Project	IEEE 802.16 Broadband Wireless Access Working Group < http://ieee802.org/16 >	
Title	A MAP IE for H-ARQ and SDMA Allocation in AAS Zone	
Date Submitted	2005-0103-2609	
Source(s)	InSeok Hwang, Jaehee Cho, Seungj Maeng, JangHoon Yang, Hoon Huh, SangHoon Sung, Jaeho Jeon, Soonyoung Yoon Samsung Electronics, Inc.	is91.hwang@samsung.com
	Ran Yaniv, Tal Kaitz Alvarion Ltd.	ran.yaniv@alvarion.com
	Dave Pechner, Doug Dahlby, Todd Chauvin ArrayComm Inc.	dpechner@arraycomm.com
Re:	Call for reply comments (Original Comment # 2189)	
Abstract	A new efficient Normal MAP IE supporting for Hybrid ARQ and SDMA allocation in AAS zone is proposed.	
Purpose	Adoption in IEEE 802.16e_D6	
Notice	This document has been prepared to assist IEEE 802.16. It is offered as a basis for discussion and is not binding on the contributing individual(s) or organization(s). The material in this document is subject to change in form and content after further study. The contributor(s) reserve(s) the right to add, amend or withdraw material contained herein.

A MAP IE for H-ARQ and SDMA Allocation in AAS Zone

[Note: The contribution was accepted in session #35. Changes were not implemented due to an editorial er

Fig. 1. Proposed SDMA Allocation Scenario

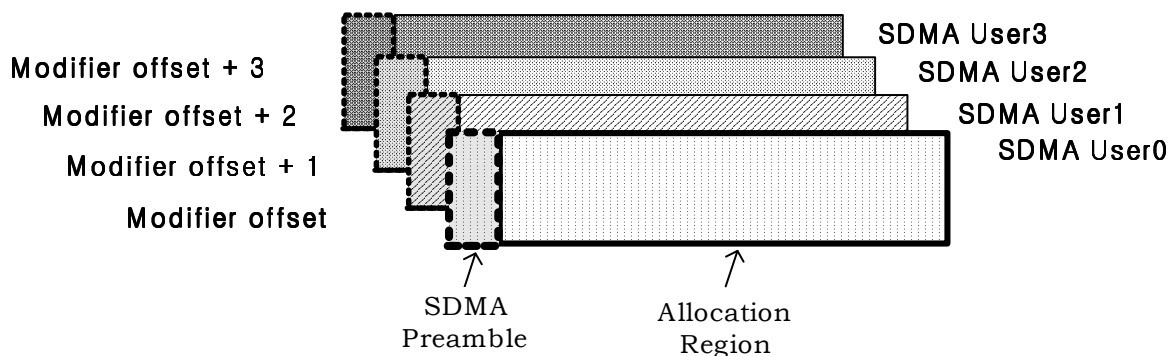
The burst allocation region of SDMA users can be fixed for scheduling simplicity and lower signaling overhead. In addition, modifier index for SDMA preamble can be extracted from description order of SDMA users. The proposed solution can be summarized as follows

- 1) Introduce Extended IUC in DL/UL MAP for SDMA allocation (not available yet)
- 2) Use '1' of '5' reserved bits in AAS_IE() to specify modifier type, "Time" or "Freq." shift

- 3) Describe the shared 2D (DL) or 1D (UL) allocation regions
 - Specify {CID, modulation/coding schemes (IUC or H-ARQ)} fields
 - ~~Implicitly assign SDMA preamble index with description order of CIDs. Due to limited length of Extended IUC, starting offset of preamble modifier is included.~~
 - Optionally include CQICH/ACKCH allocation IE for DL burst and uplink power adjustment IE.
 - **Optionally specify pilot patterns for SDMA users**
- 4) Use a pointer IE for special Sub Map including the all information elements described above.

Figure XXX – Pilot patterns for AAS mode in AMC zone. Symbol offset is relative to the beginning of the zone. Pilot polarity for each pattern is given in brackets.

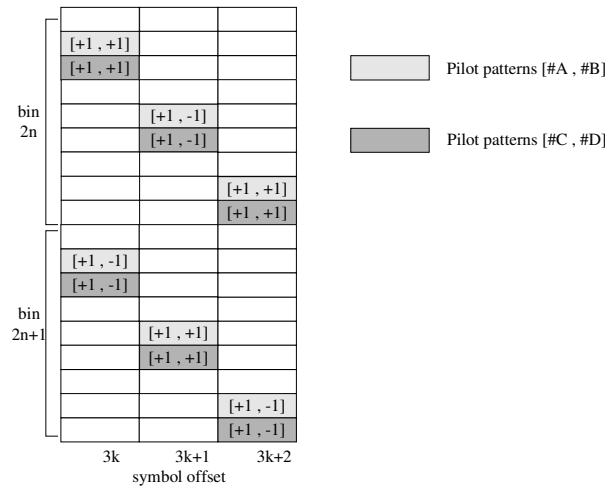
[Add the following new section]

8.4.6.3.2 AMC support for SDMA

The pilots in an AMC AAS zone are regarded as part of the allocation, and as such shall be beamformed in a way that is consistent with the transmission of the allocation's data subcarriers. In an SDMA region, the pilots of each allocation may correspond to a different pilot pattern. A pilot pattern consists of location and polarity. The pilot patterns are depicted in figure XXX. Data subcarriers shall be punctured to obtain patterns #2 and #3. Subcarriers shall only be punctured if there is an allocation associated with the corresponding pattern, as described in the AAS SDMA DL IE() and AAS SDMA UL IE(). Only MSSs that support all four pilot patterns, as indicated by their capability in 11.8.3.7.X, shall be assigned allocations in an SDMA region where pilot patterns #2 and #3 are used. Data subcarriers shall be punctured after constellation mapping in the case of CC encoding, and prior to constellation mapping in the case of CTC encoding. In the latter case, the FEC block shall be truncated to accommodate the punctured subchannel structure, and the data subcarrier enumeration of Eq. (116) shall not be applied. Instead, data subcarriers within a slot shall be enumerated starting from the first OFDMA symbol at the data subcarrier that is lowest in frequency, continuing in ascending frequency order throughout the slot's subcarriers in the same symbol, then going to the next symbol at the subcarrier lowest in frequency, and so on.
